Title: Advisory Committee on Reactor Safeguards  
Plant License Renewal Subcommittee

Date: Tuesday, November 4, 2003

The purpose of this meeting is to discuss the license renewal application for the Robert E. Ginna nuclear power plant and the associated NRC separate evaluation report with open items.

# Lower Reactor Vessel Inspection

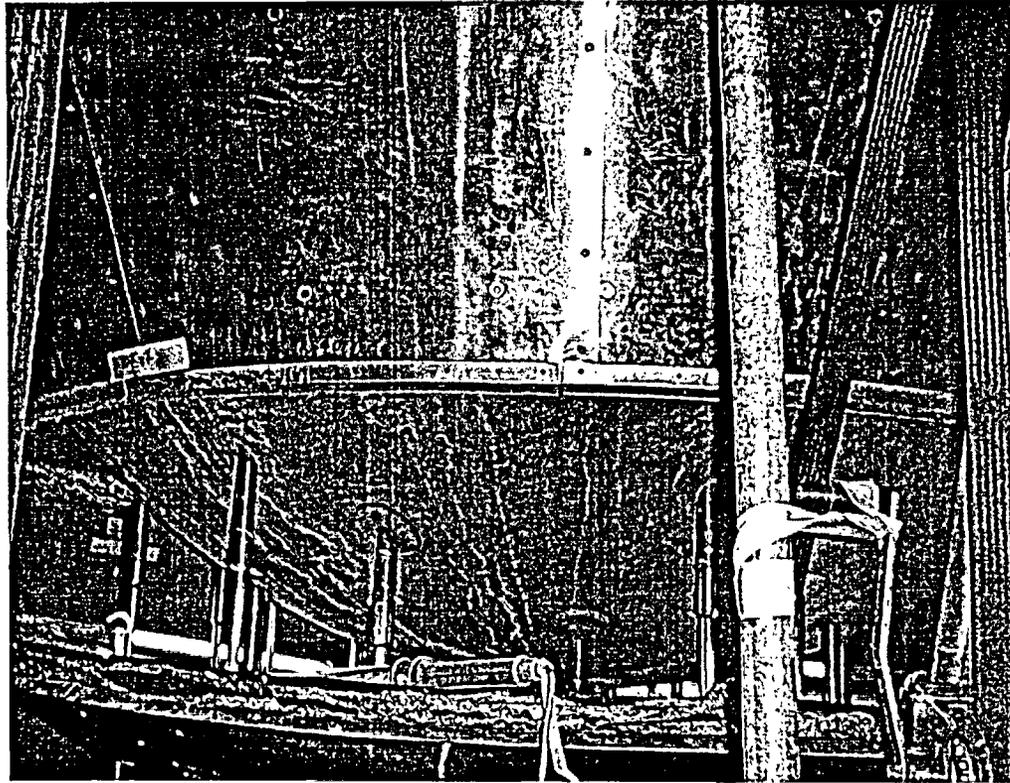
17 MR. WROBEL: The other major issue that  
18 we looked at was on the lower reactor vessel head  
19 inspection. This detail of the penetration, as you  
20 can see, the paint and weld pad, everything was in  
21 excellent condition. There was no leakage, no  
22 indication of leakage through the nozzles, boric  
23 acid and, again, it came out as good as we would  
24 expected on the bottom head.

19 MR. FORD: Given the observations at  
20 South Texas, you could be awkwardly minded, if you  
21 like, and say here you just painted over the annulus  
22 with paint and there's boric acid on top of that.  
23 Is that a reasonable question?

- Results:
  - Carbolene zinc based paint on bottom head and weld pad was in good condition
  - No leakage through nozzle penetrations
  - No indication of boric acid or boric acid buildup from operational leakage
  - Cleaning performed to facilitate future inspections

# “B” Sump

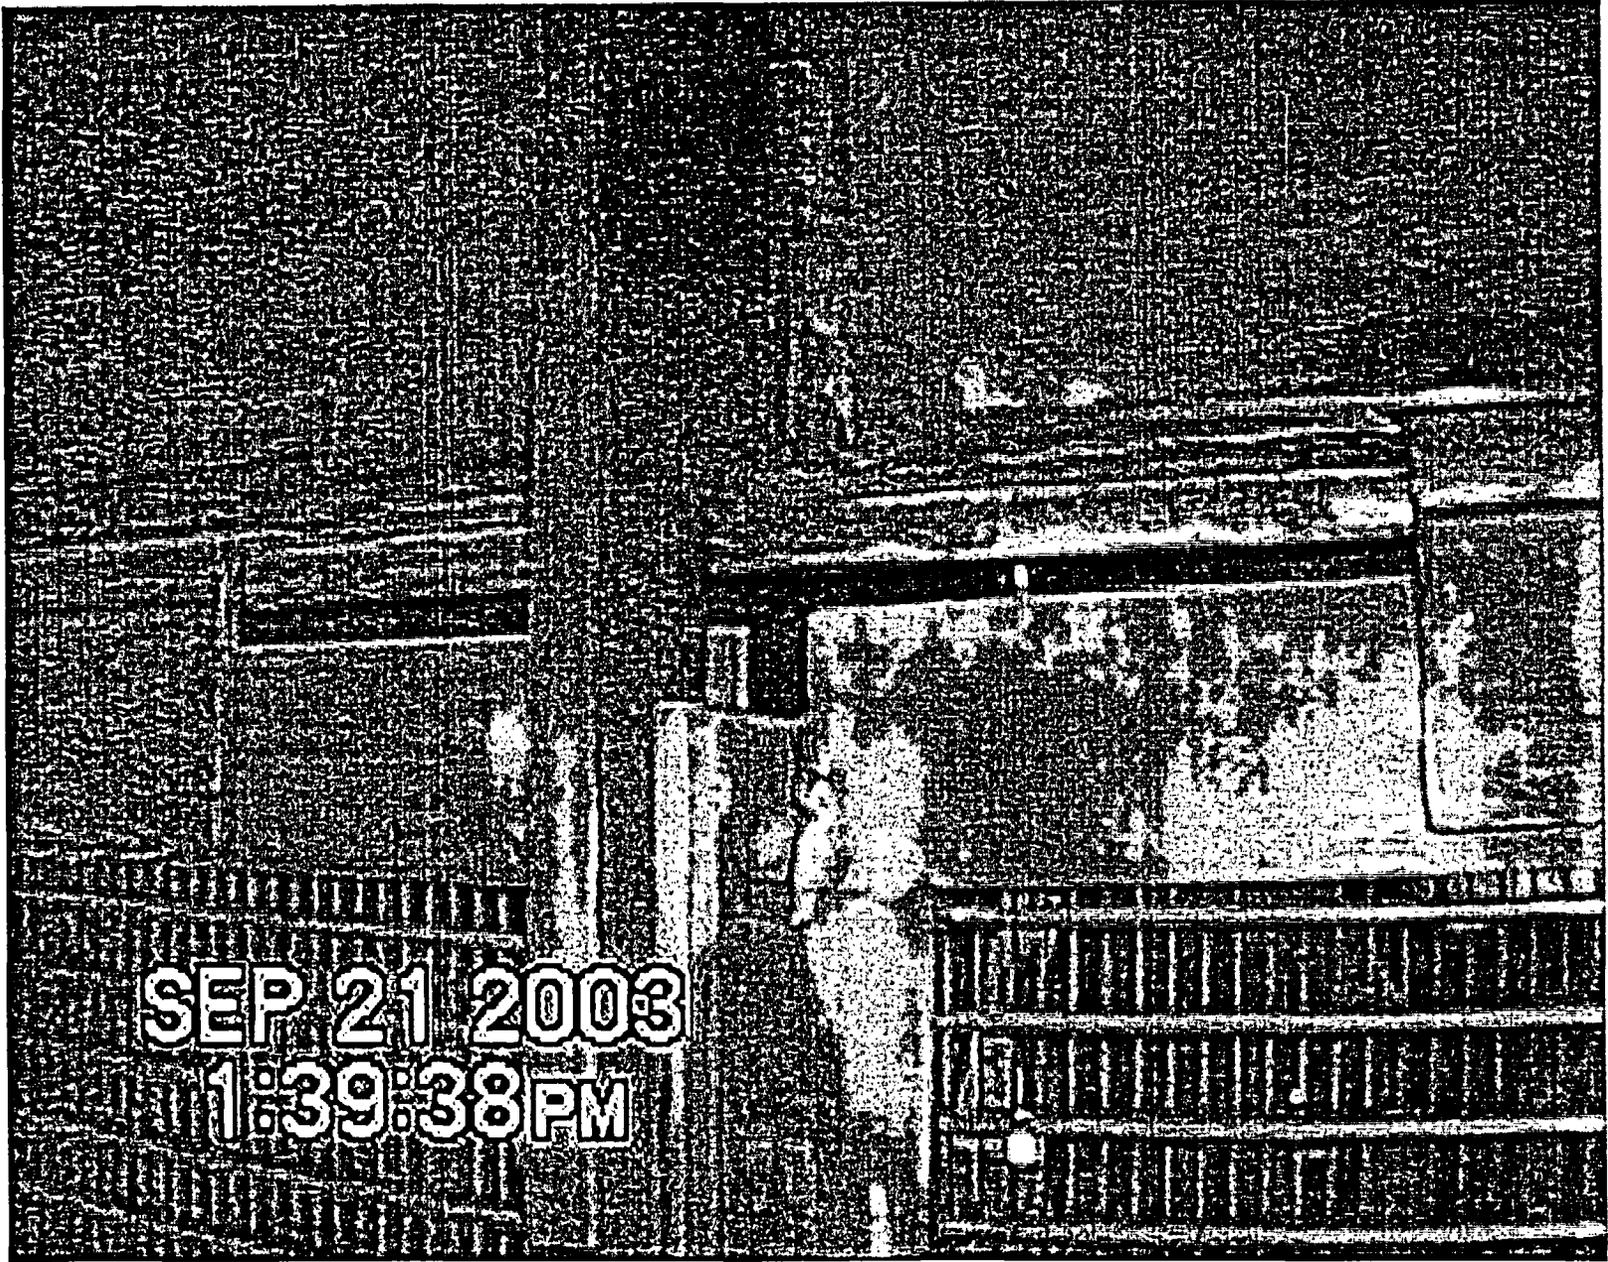
10 MR. LEITCH: Absent that bypassing, can  
11 you make any comment on the adequacy of the screens  
12 that do exist? In other words, have you revised  
13 your operating procedures or is there ongoing  
14 analysis to confirm that?

23 MR. LEITCH: Well, I guess my question,  
24 it seems to me that there's some kind of an NRC  
25 correspondence to all PWR licensees. I don't know if

- Inspection raised 3 issues:
  - Sump screen mesh per UFSAR should filter debris  $> 0.25''$  in diameter. Installed mesh size is  $3/16'' \times 9/16''$ .
  - Bypass flow issue
  - Foreign material found
